DWR EXHIBIT I
Application, File No. 45,574

**APPLICATION FOR PERMIT TO
APPROPRIATE WATER FOR BENEFICIAL USE**
Filing Fee Must Accompany the Application
(Please refer to Fee Schedule attached to this application form.)

ASR Project DW-7

Re: Application
File No. 45,574

**Figure 1. - Equus Beds Groundwater Management District No. 2
 Aquifer Storage and Recovery Project Map
 July 13, 2004**

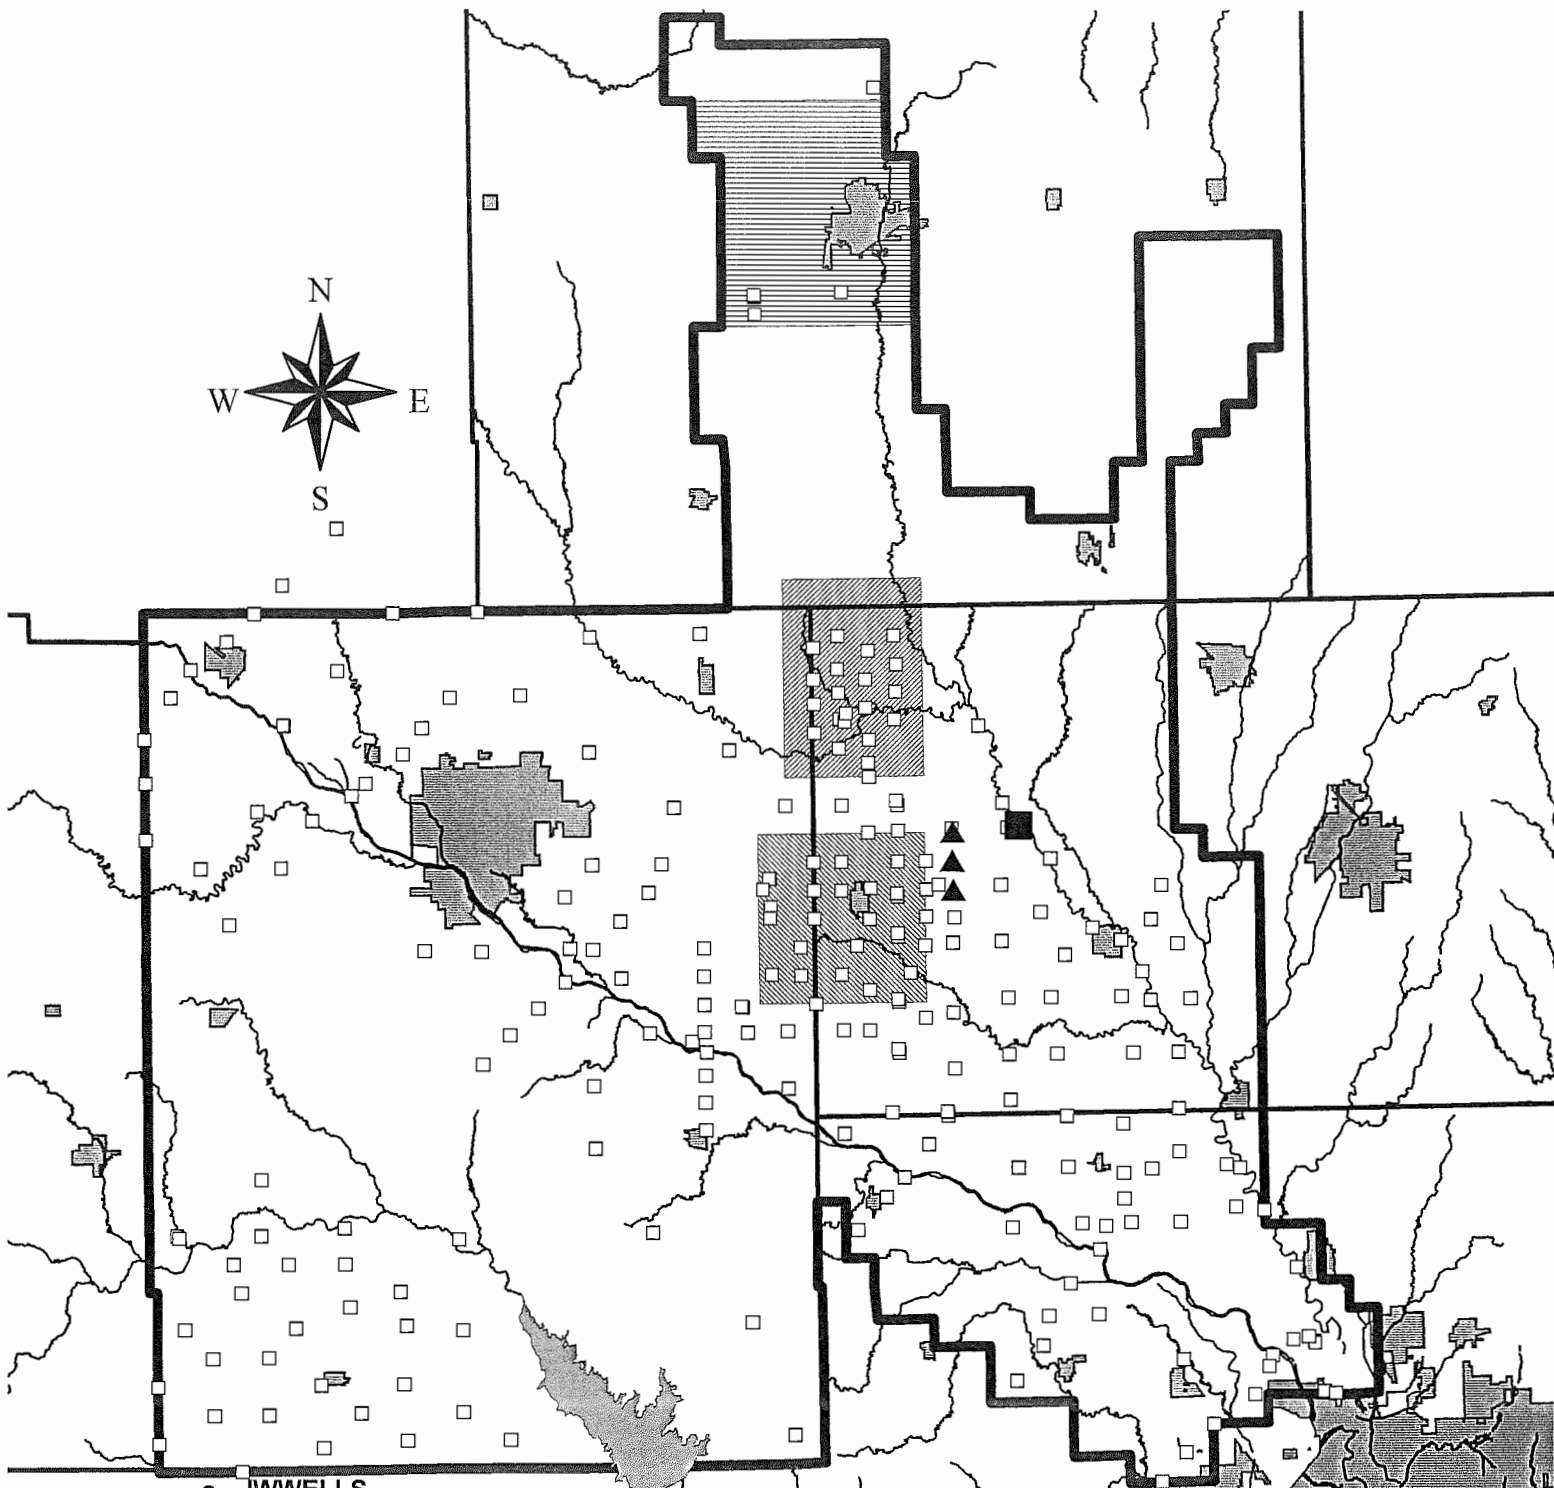
The proposed bank storage well shall be utilized only when river flow exceeds 42 cubic feet per second (cfs) from April through September, and 20 cfs from October through March, as measured at the United States Geological Survey (USGS) gage located at Highway 50 near Halstead (figure 1).

Figure 2. – Application No. 45574 Site Map - 10W/08-23S-2W
Prepared by: Equus Beds Groundwater Management District No. 2 - 06/30/04

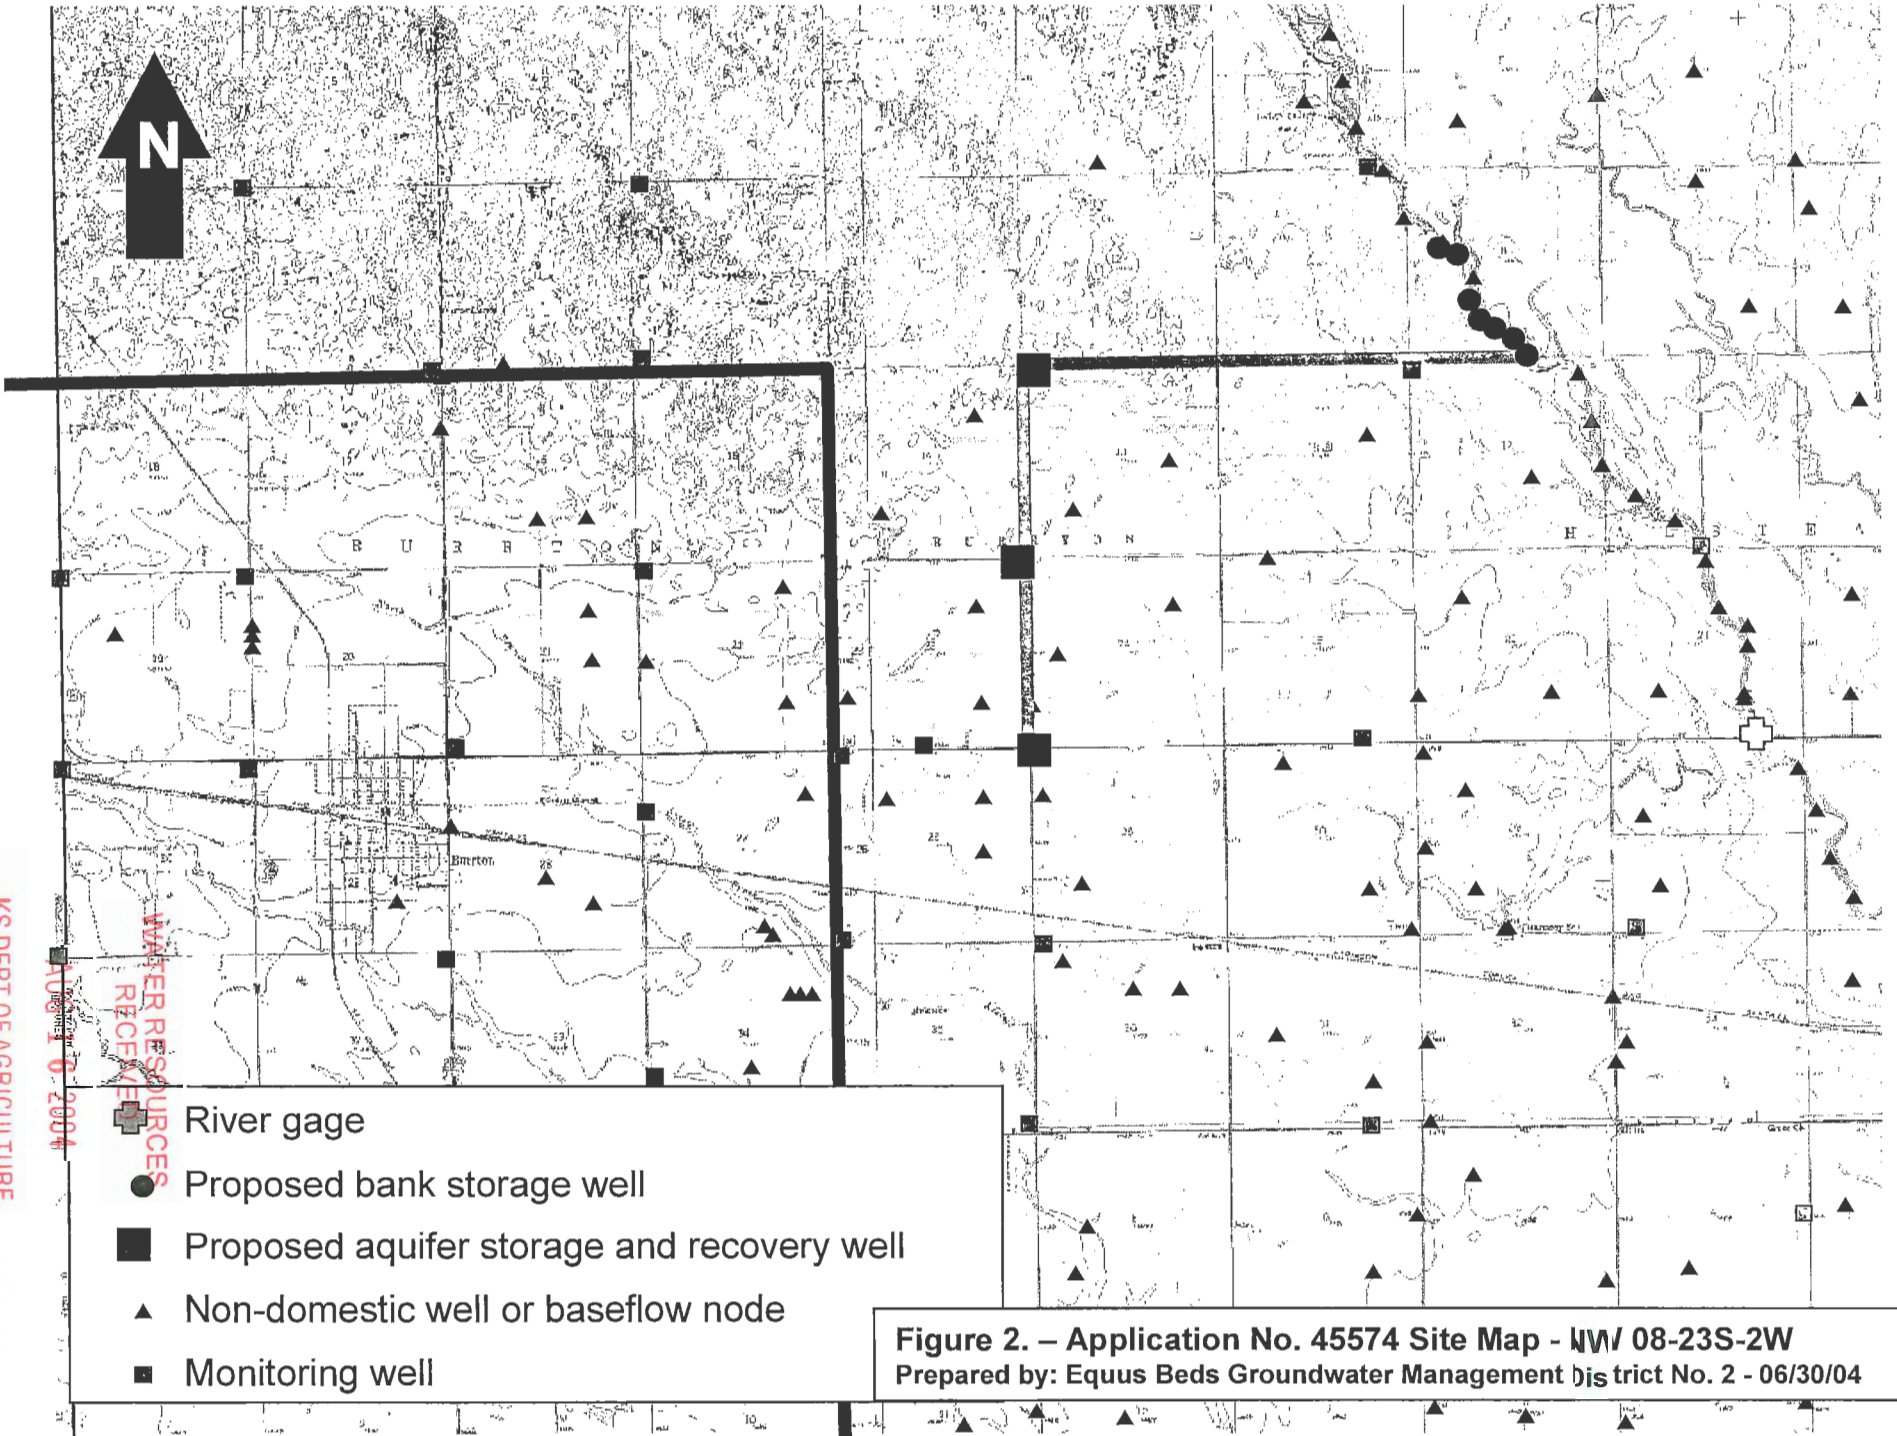
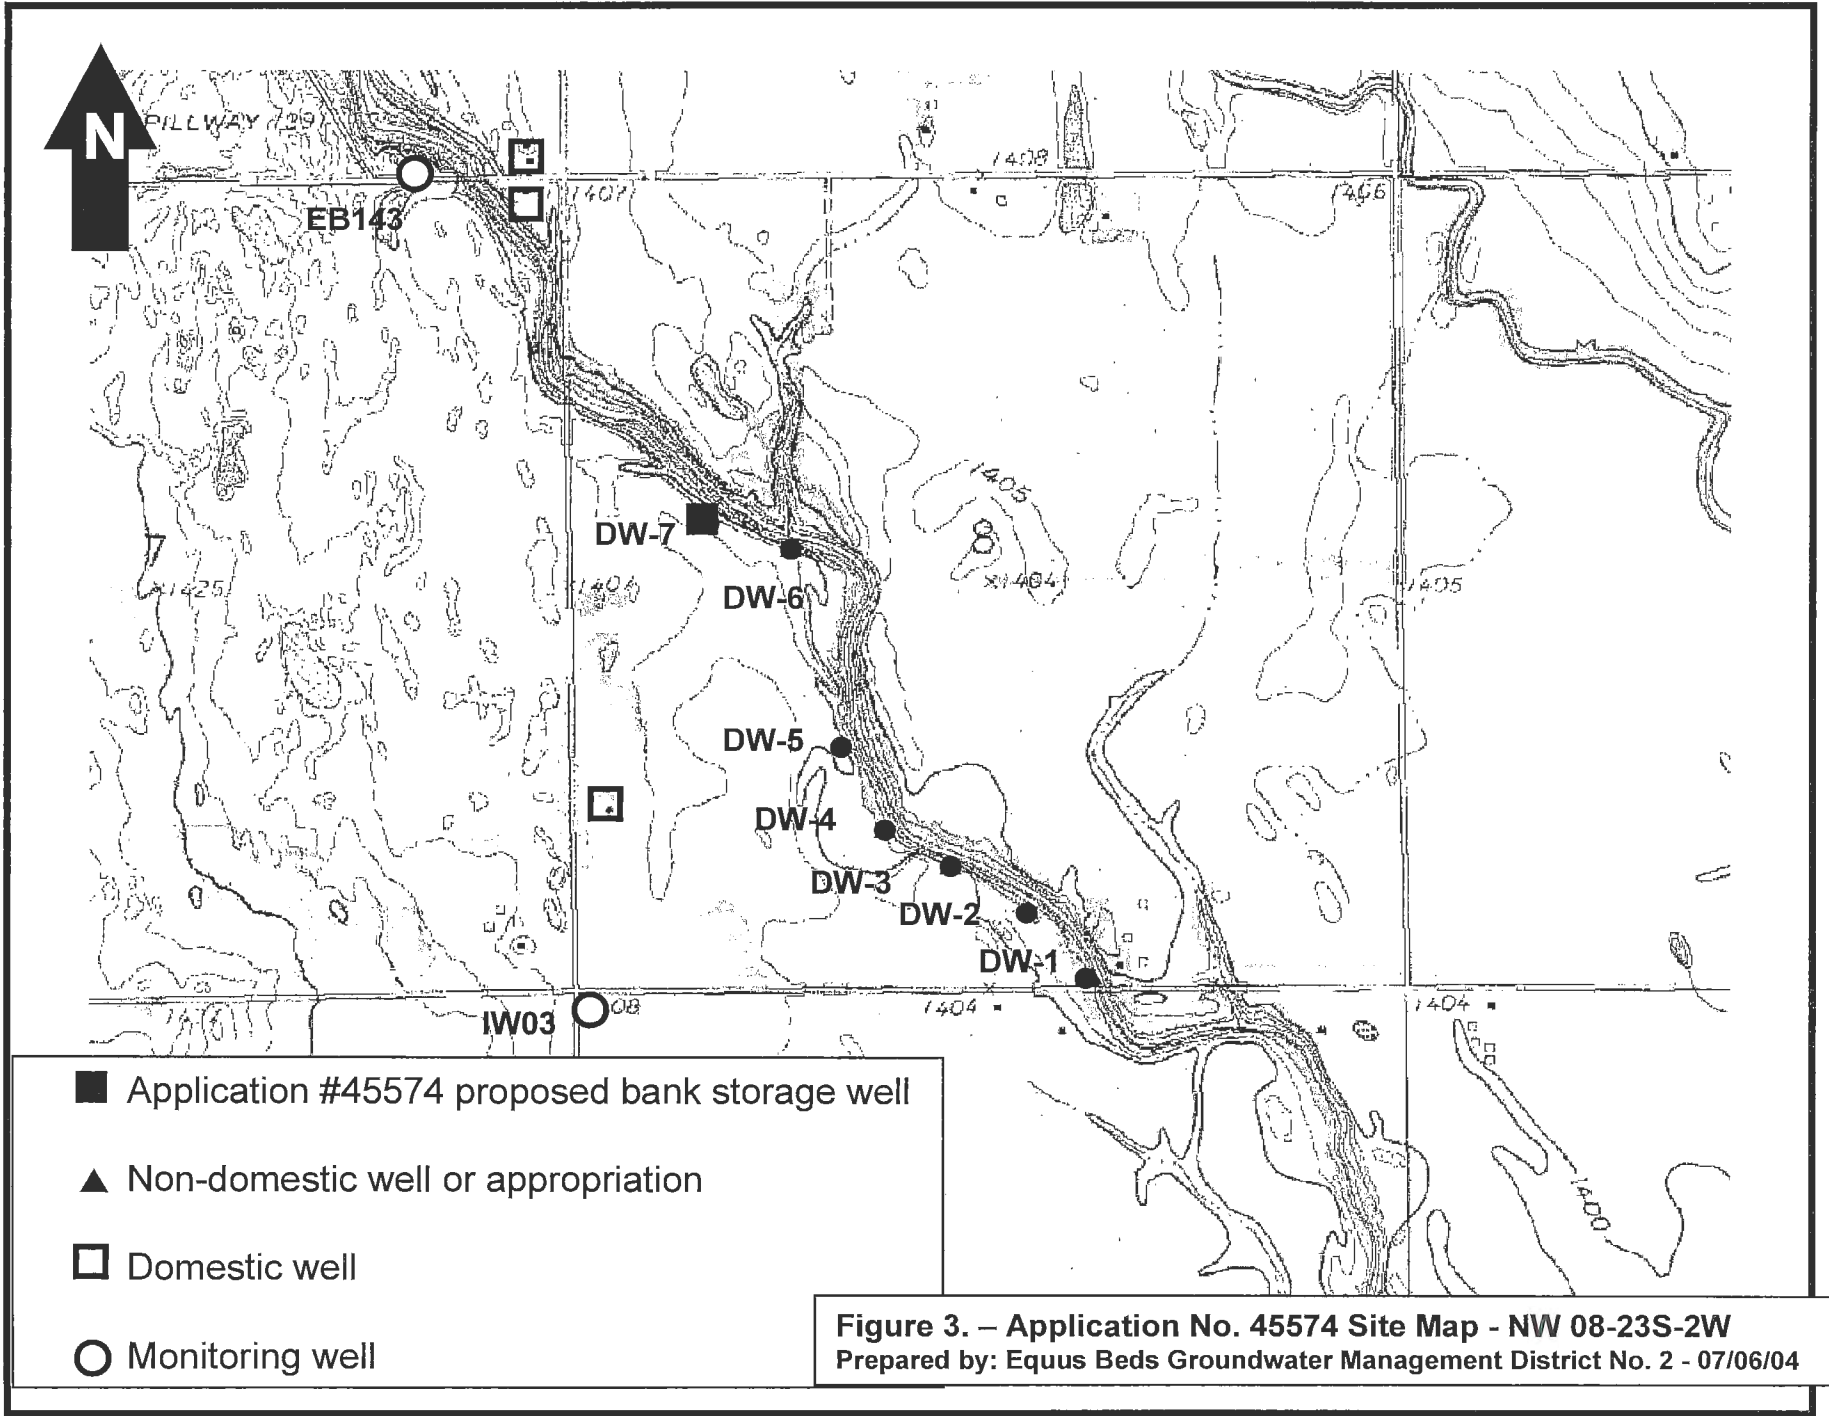
The proposed source water for the applicant's artificial recharge use in the aquifer storage and recovery system, is bank storage water to be diverted from a proposed well located in the SE-SW-NW of Section 8, Township 23 South, Range 2 West (figure 2).

Figure 4. –
 Application
 No. 45574
 Lithologic Log
 and Construction
 Design for
 Bank Storage
 Well

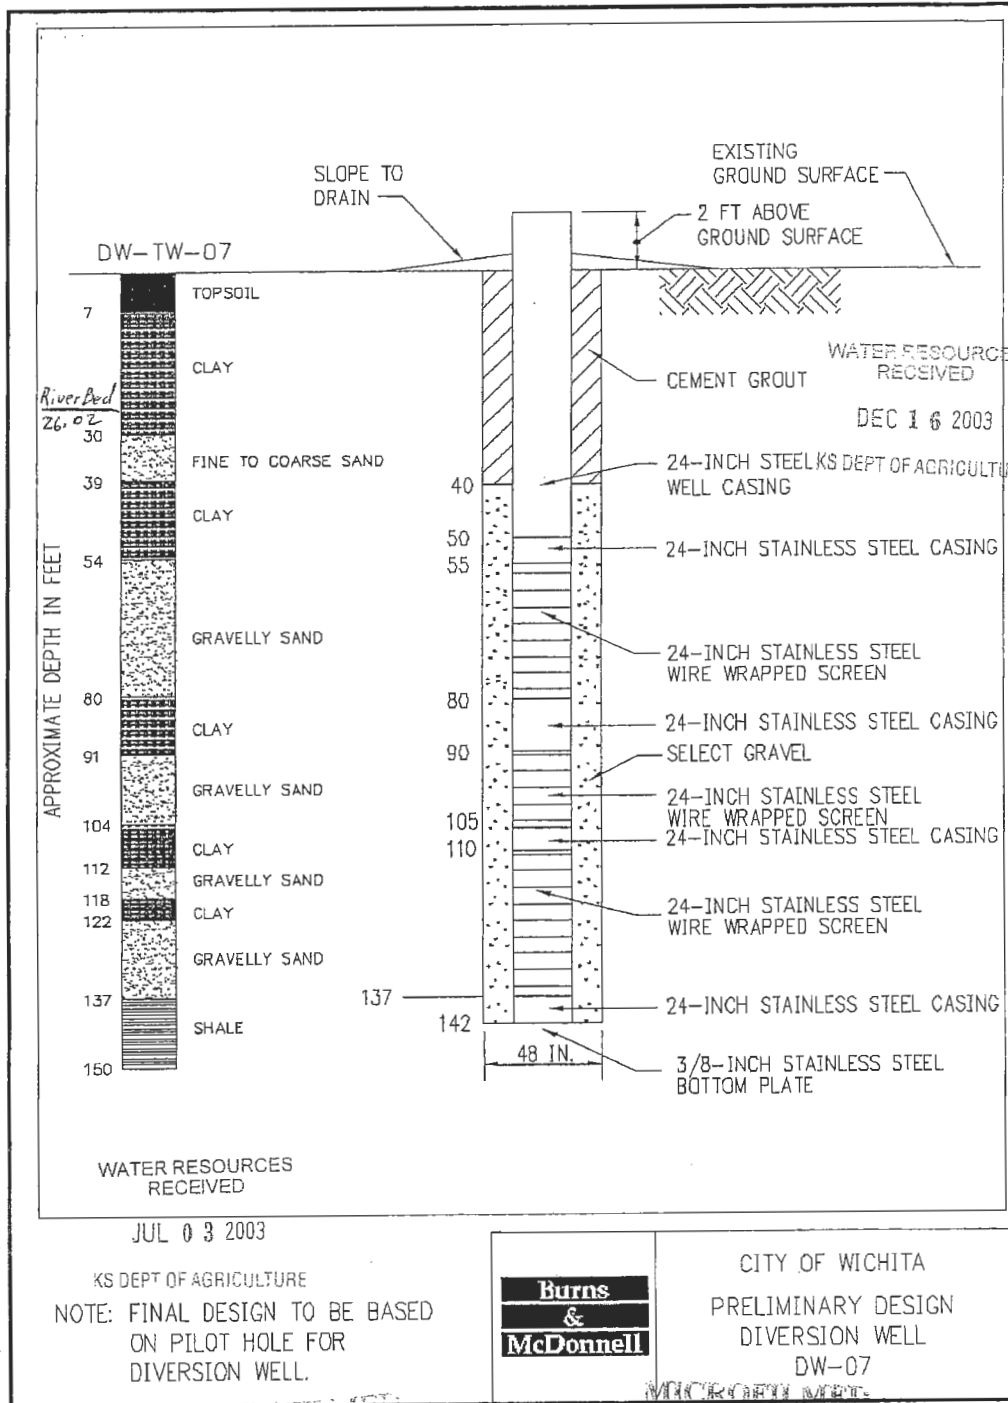
The lithologic log of the proposed well site indicates that the aquifer is comprised of alternating sand and clay layers, with shale encountered at 137 feet (figure 4). The log indicated that clay units exist at depth ranges of 39 to 54 feet bls, and 80 to 91 feet. The horizontal extent and continuity of the clay units were not determined. The lower portion of the aquifer consisted of interbedded sand and clay units throughout from 91 to 137 feet bls.

The application's proposed well depth is 137 feet bls (figure 4), with proposed screen intervals set from 55 to 80 feet bls, and 90 to 137 feet bls. The well is proposed to be screened in the lower portion of the aquifer below the clay unit located from 30 to 54 feet bls. The applicant proposes to utilize a 24-inch diameter well casing and screen.
